Reg.12-10/A.12-10-009
SDG&E CNF PTC Application

Subject: ED-SDG&E-04 SDG&E Response

SDG&E January 17, 2014 Response
A. 12-10-009 Cleveland National Forest Power Line Replacement Projects PTC
ED Data Request 4 Dated December 19, 2013
ED-SDGE-004: Q 1-7

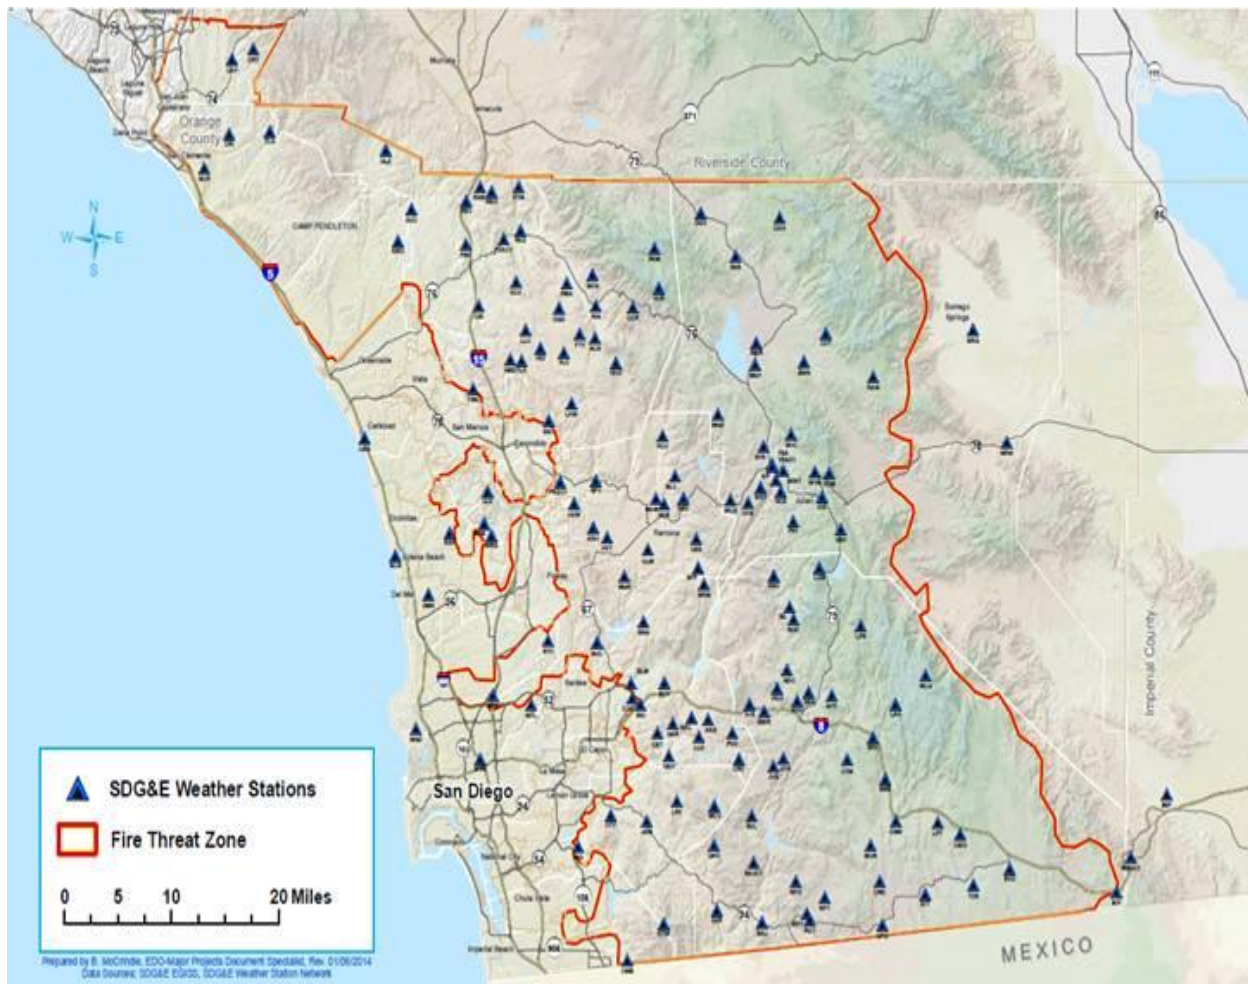
- 2.1 In order to understand the usefulness of the SDG&E weather station network in terms of determining the areas where electrical transmission system hardening is best applied, we request additional weather station network information. In particular, please provide the type of weather stations in use, a map of their locations, how they are monitored (i.e., via the Web or other remote system), and whether there are any other current uses for the weather station data, such as determining when field activities are restricted (e.g., when humidity is lower than 10% or winds over 15 mph, then no hot works should occur, etc.).
- 2.2 Please describe how SDG&E applies the weather data collected in their decisions to shutoff power lines (i.e., what level wind would trigger shutoff; what other weather conditions would lead to a similar action?)

2.1 The SDG&E Weather Network is very sophisticated with both cellular and SCADA communications creating redundant and reliable communication. The multiple streams of data allow us to ingest the data into internal operational interfaces while simultaneously streaming the data onto the web for public use. Every weather station is standardized in terms of height off the ground, 20 feet. Standard hardware includes solar panels, antennas, mounting hardware, cable, conduit, batteries and enclosures. Anemometers, Temperature/Relative Humidity, Dataloggers and SCADA are standard equipment.

- Anemometer (RM Young 05106 Wind Monitor)
- Temperature/Relative Humidity Probe (Vaisala HMP155A)
- Datalogger (Campbell Scientific CR1000) and handheld keypad for on-site back-up.
- SCADA 12-volt power supply (incl. Sun saver voltage regulator, 12-volt 84AMPHR battery and 20- watt solar panel)
- Sierra Wireless Airlink CDMA Cellular Digital Modem for Verizon systems
- Sierra Wireless Airlink GPRS Cellular Digital Modem

Below is a map showing the location of the 144 pole mounted weather stations and 5 Remote Automated Weather Stations (RAWS) owned and operated by SDG&E. This weather network has been installed to monitor weather conditions at locations across the service territory to support the safe and reliable operation of the distribution and power line systems.
